CASINO OVERLAY SITE PLAN REVIEW 30-DAY REVIEW

Re: Casino Overlay Site Plan Review

MGM Springfield
 Site Plan Review – 30 Day Review Comments and MGM/Consultant Responses
 December 21, 2015

APPENDIX A
12-18-15-In-Line Bus Bay Exhibit

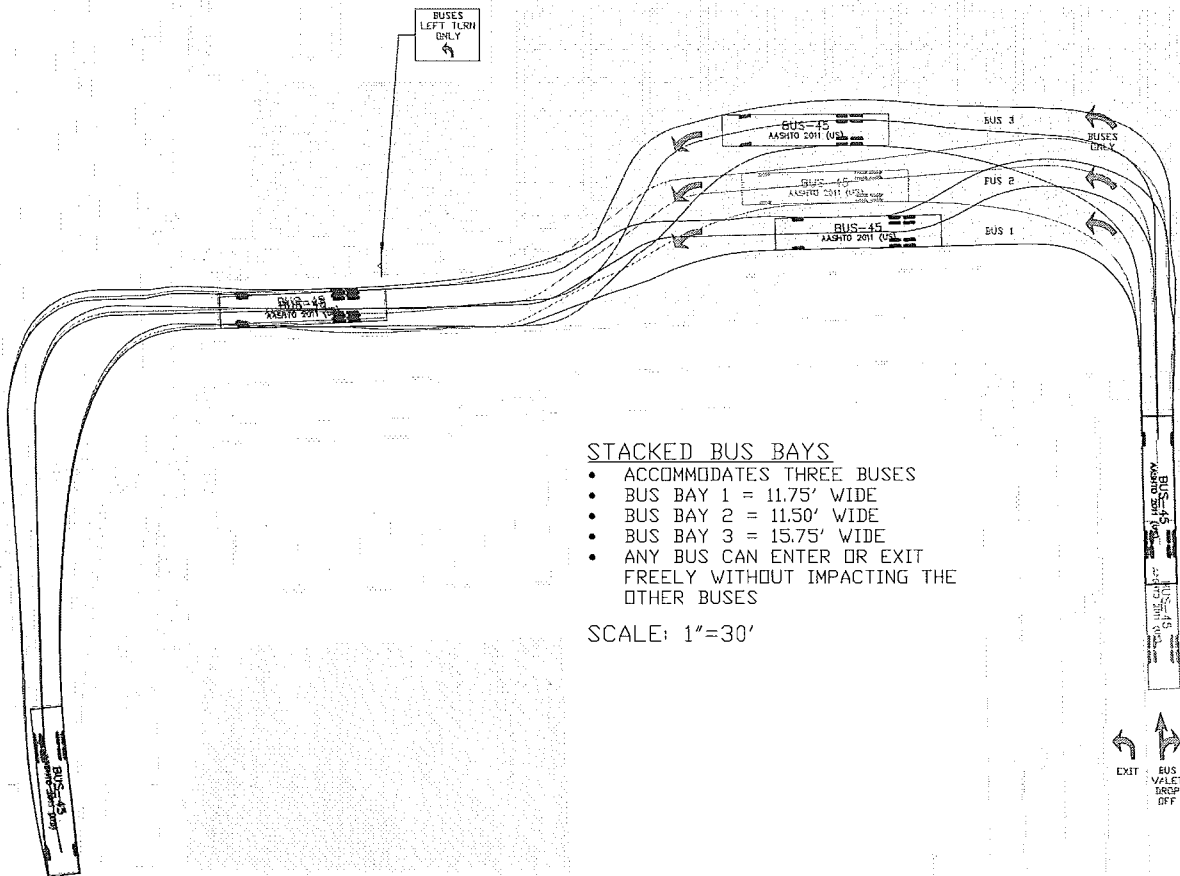
18	<p><i>The layout of the roadway curbs, etc. in the proposed bus drop off area does not appear to have been adjusted dramatically from the previous design that did not include bus movements. Please show geometrically with proper turning templates that busses can make the necessary movements without impacting adjacent lanes while turning left onto State St. Please be aware that right turns on to State St. will only be allowed for passenger vehicles.</i></p> <p>Reference Appendix A. The bus depot design and the accommodations for access onto State Street have been adjusted in response to City comments.</p>
19	<p><i>Please review the left-turn movements, especially for busses, from MGM Way onto State St. The turn is occurring at a pedestrian crossing location and the geometry appears very tight.</i></p> <p>The proposed median pedestrian refuge island has been modified and shifted slightly to accommodate the bus turns as noted above. Reference Allen & Major revised site improvement plans (dated 12-22-15).</p>

- ACCOMMODATES THREE BUSES
- BUS BAY 1 = 11.75' WIDE
- BUS BAY 2 = 11.50' WIDE
- BUS BAY 3 = 15.75' WIDE
- ANY BUS CAN ENTER OR EXIT FREELY WITHOUT IMPACTING THE OTHER BUSES

APPENDIX B
12-18-15-Level One Plan

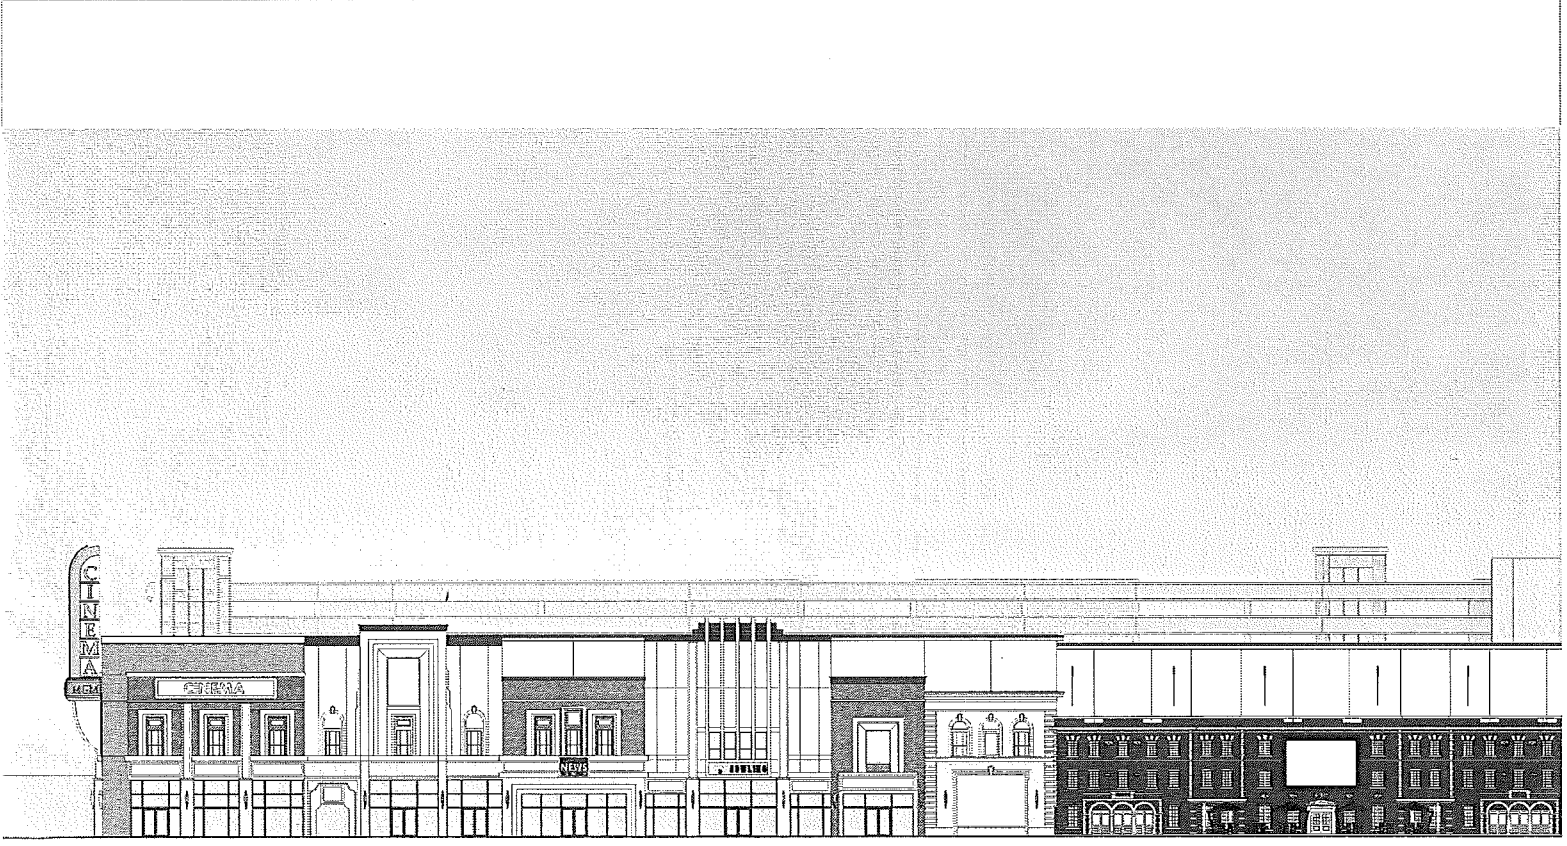
52	<p><i>The retail along the pedestrian alley facing the Armory Marketplace has been reduced (as cited above) from both the HCA and FEIR plans. The resulting reduction in actual storefronts/businesses, potential tenants/uses (originally shown in the FEIR as a mix of Food and Beverage and Retail vs. "retail" and potentially blank walls of the bowling alley) and overall square footage is concerning in that it lessens the potential attraction and draw of a more robust, lively retail area/corridor; why has this been reduced? How does this plan create that same attraction as in prior approved submittals to ensure a successful, unique restaurant/retail experience?</i></p> <p>Through the incorporation of the seasonal ice skating rink, farmers market, relocated church, Armory, and various retail storefronts directly attached to the armory marketplace, the allure and appeal of this space has been improved from the original HCA plans. The design of the bowling alley elevation architecturally satisfies the urban design approach for the project, with various articulations and signage elements. The provision of retail storefronts along Main Street and State Street will now increase the area of effect for new retail attractions across the site and encourage increased pedestrian activity throughout the project. Refer to updated Level One Plan (Appendix B) and updated elevation set (Appendix C), attached.</p>

58	<p><i>Is the alley between 101 State Street and 95 State Street an entry into the Casino? Can you explain further the connection to the Casino from 101 State Street through the lobby space?</i></p> <p>The alley between 101 State Street and 95 State Street is not an entry into the casino. This area is currently where mechanical functions for 101 State Street and 95 State Street occur. The connection from the 101 State Street lobby into the casino is a controlled access point only for MGM employees.</p>
59	<p><i>Are there access points into the Casino along State Street? Through Starbucks? Through the historic façade at the Food Court? Through the terraces?</i></p> <p>Pedestrians can access the casino through Starbucks and the food market terrace.</p>
60	<p><i>The new location and design of the Hotel as more of an urban infill, low/mid-rise scenario has much appeal and definitely helps energize further economic development along Main Street. While the "front door" and lobby of the Hotel appears at Howard and Main Street, how/where do you plan on accommodating the typical demands of queuing, drop off, valet etc. related to the hotel use?</i></p> <p>The drop-off for the hotel patrons will occur within the parking garage. This is considered a primary entrance to the property and will be signed accordingly. Valet, drop off, and taxi access will occur in this area. Through continued discussions with the City of Springfield, the City has expressed interest in having two taxi queuing spots on Main Street, adjacent to the hotel lobby indicated on the Level One Plan (Appendix B). We will continue to explore taxi queuing with the City.</p>

APPENDIX C
12-18-15-Progress Elevations

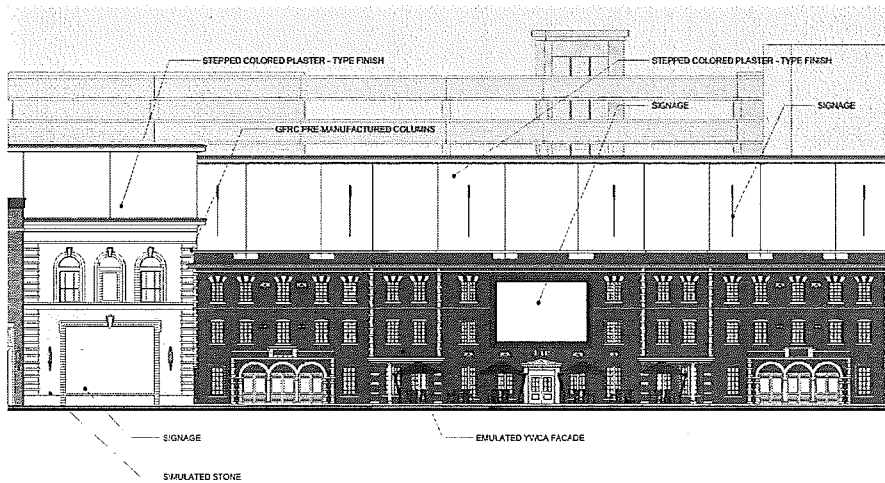
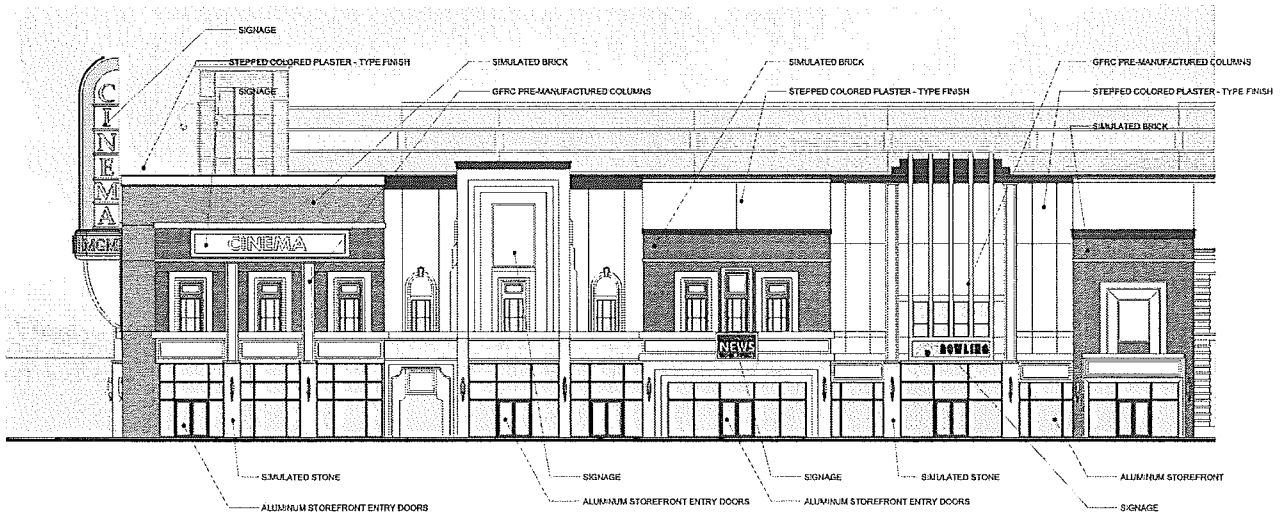
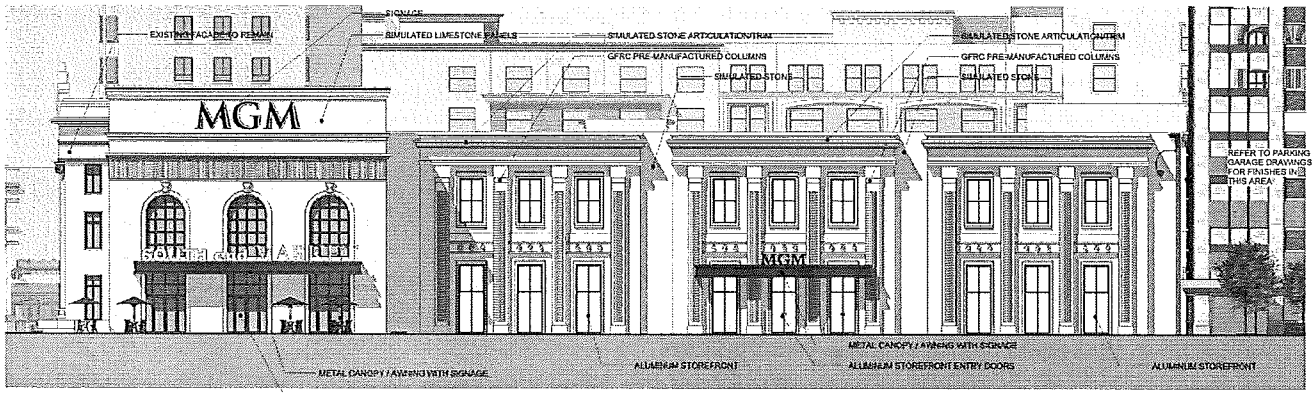
63	<p><i>The drawings reflect a very conceptual level of design for the elevations. Additionally, while many of the plans and interior layouts have advanced or changed, some of the elevations remain the same (former Porte Cochere entry, garage elevations, events plaza entry) and do not reflect the changes in entry, uses, etc. This requires further discussion and/or explanation as to the key areas of emphasis or importance on the elevations (representing major entry points, reflective of the use behind such as retail, etc.).</i></p> <p>The current elevations correctly reflect the points of entry and uses within. Through continued discussions with the City of Springfield, the elevations have advanced to further to highlight specific entry locations and the refinement of the Entertainment block elevations. See progress elevations included as Appendix C.</p>
----	---

Planning Design Comments - Elevations, Materials & Signage (Union Street Elevation)	
67	<p><i>Corner building at Union and Main needs detail. Can you provide more detail as to the design of improvements to the building if a renovation, or new elevations if all new?</i></p> <p>The retail at the corner of Union and Main will be new construction. The elevations relate to the same architectural character shown on the retail and entertainment façades. However, MGM is interested in discussions with potential tenants progressing before committing to the precise detail of that construction.</p>
Planning Design Comments - Elevations, Materials & Signage (Entertainment Block Elevation)	
68	<p><i>There is a significant scale shift between the theater and bowling alley side and the YWCA "emulated" elevation. Please provide more detail on these elevations and what is intended with the emulated façade.</i></p> <p>Through continued discussions with the City of Springfield, the design of the entertainment block elevation has advanced to relate more closely in scale with the emulated YWCA façade. Material differentiation has been detailed and signage elements have been added to improve the scale shift between the façades. The emulated façade is intended to closely relate to the existing YWCA materials, proportions, and articulations, adjusted to function within the project. Current elevations are included as Appendix C.</p>

69	<p><i>The "colored plaster" façade above the YWCA needs detail and design. How does this integrate with the theater façades to the left? Perhaps this can be "designed" to help mitigate the significant scale shift between the two.</i></p> <p>Through continued discussions with the City of Springfield, the design of the colored plaster façade above the emulated YWCA façade has been advanced to show detail in the division of plaster and the incorporation of numerous banners along the façade. These enhancements have linked both portions together into a more harmonious façade. Current elevations are included as Appendix C.</p>
